#### PLANNING AND TRANSPORTATION

**Erection of Dwellinghouse**

Land To The South East Of Tappernail Farm Hillcrest Square Reddingmuirhead

P/16/0215/FUL

Just from looking at the Site plan (AG(0)102), I was concerned that the post and wire fence and visibility splay were not shown correctly. Having checked it on-site it is clear that the drawing is wrong.

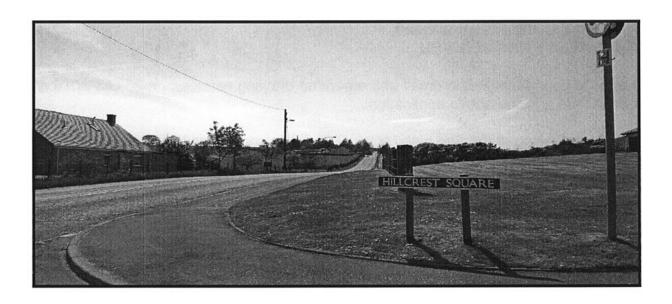
As shown on the sketch I have attached, the fence & hedge at the junction is shown (in red) as 2.5m from the road edge and on site (in blue) it is 4.5m from the road edge. At the other end the fence and hedge are again shown 2.5m back from the road edge where on-site it is 3.8m. This means that the drawing shows the fence and hedge obscuring the visibility splay and so obviously totally unacceptable from a road safety point of view. The existing fence at the site delineates the proper visibility splay as required and so I would ask that the drawing is amended to reflect this.
